Application No. SSD-47105958

Location: 24A Kingscliff Street, Kingscliff

Table 1 - SSD-47105958 Special Report Reviews and Comments

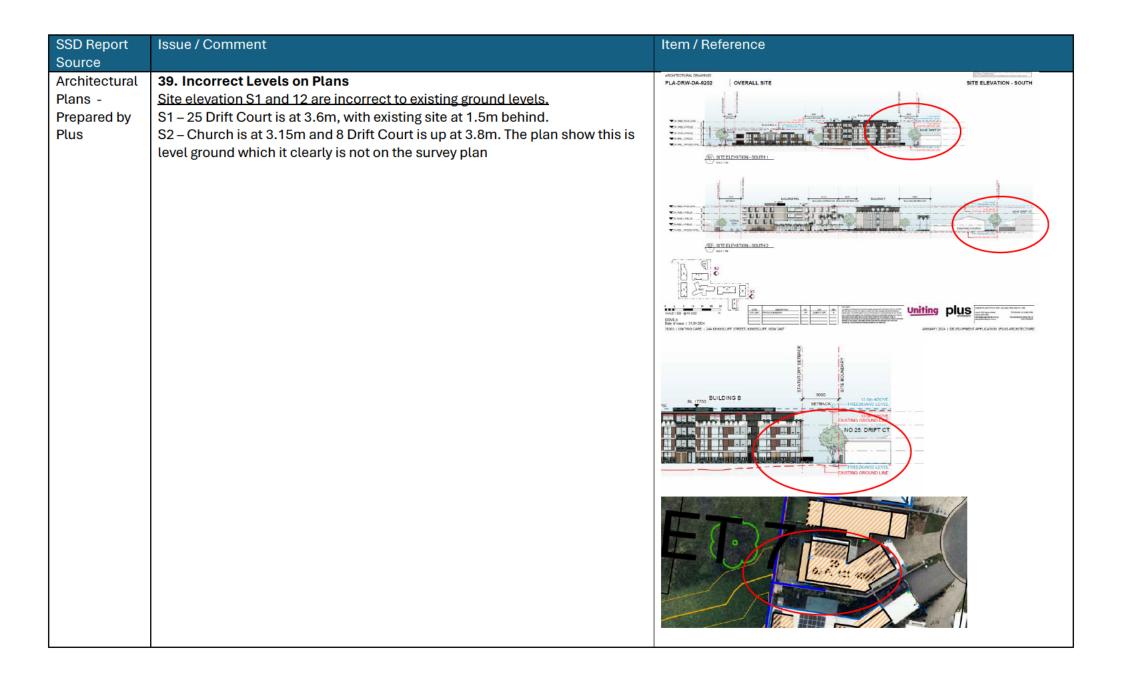
SSD Report	Issue / Comment	Item / Reference
Source		
Architectural Plans - Prepared by Plus	32. Site Context Plans misinterpret surrounds to substantiate proposal The site context plan references other existing building types to demonstrate precedence of height and land use. The report fails to provide actual context to these examples which demonstrate clear inconsistencies with the proposal. These include: 1. Beach Street / Marine Parade examples include ground floor parking recessed into the dune / land scaping with three net levels of units above. Height is taken from 'natural ground level'. The proposal seeks to raise the ground level, then measure heights and levels which is incorrect and misleading. 2. The neighbouring retirement facility is predominantly single storey dwellings only 3. Example 3 on Kingscliff Street, includes ground level parking (no basement and includes the upper level designed into the roof structure façade, therefore reducing the perceived height of the development. It is recommended that site context plans are rectified to more accurately provide the correct context and subsequent differences the proposal has to the surrounding built area, as opposed to similarities.

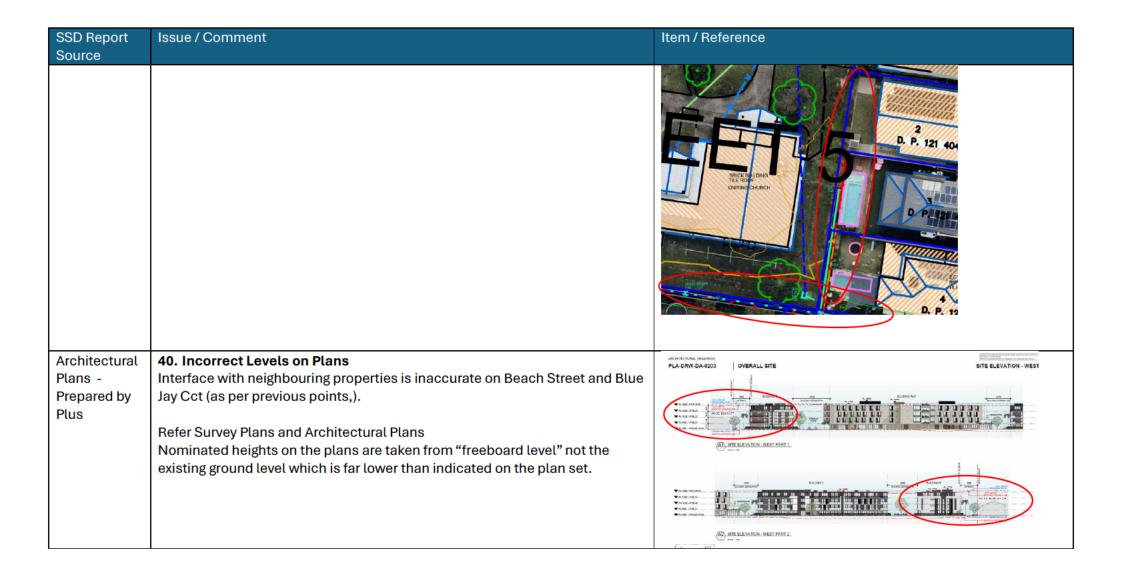
SSD Report Source	Issue / Comment	Item / Reference
Architectural Plans - Prepared by Plus	30. Deep Planting Zones and Detention basin near Church The plans show proposed deep planting behind the church and in the church car park area as well as detention basis directly adjacent. The architectural plans conflict with traffic and landscape plans for this area along with the levels of both the existing church and surrounding neighbour walls. The deep planting zone in the car park includes proposed permeable grassed areas which does not comply to AS2890 in maintaining sealed and formalised car parks. In addition, the low point of the site, landscaped batter over basins and basements will likely result in overland flow or pooling in the parking areas. This will result in maintenance issues as well as trip hazard issued for users of the car park (particularly the elderly users),	CHACAL TO THE REST OF THE PROPERTY OF THE PROP

Architectural Plans - Prepared by Plus	31. No Deep planting on South-eastern extent of site The deep planting zone is not identified along the south-eastern corner of the site, however established landscaping is shown on the ground level landscaping plan. It is unclear whether mounds on top of the detention tank are proposed to facilitate the level of landscaping proposed at these locations.	SETBACK SETBACK BETTACK BET

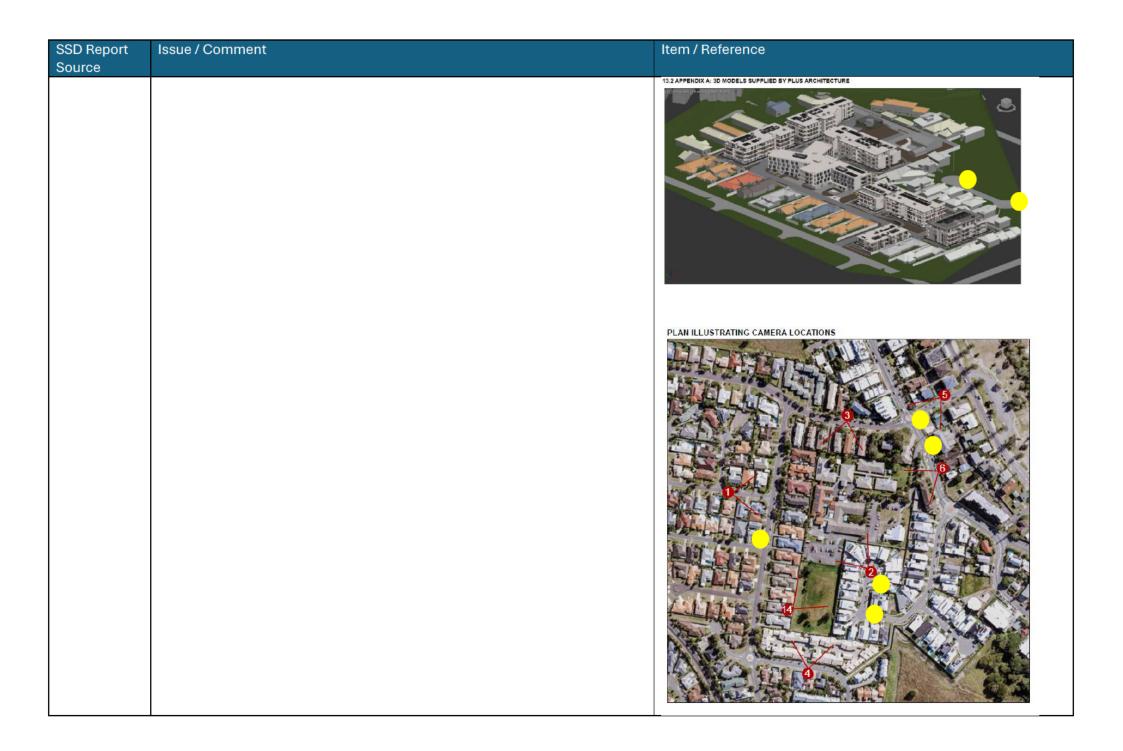
Visual Impact Report – Prepared by Ethos Urban	47. Lack of viewpoint from Drift Cout (No.s 25 to 35). Properties 25 to 35 Drift Court are expected to have a significant impact to privacy, visual, amenity and shadows as a result of the development. These properties are not adequately addressed as part of the visual impact assessment. It is recommended further detailed visual impact renderings are undertaken to address these concerns. Updated location are shown adjacent.
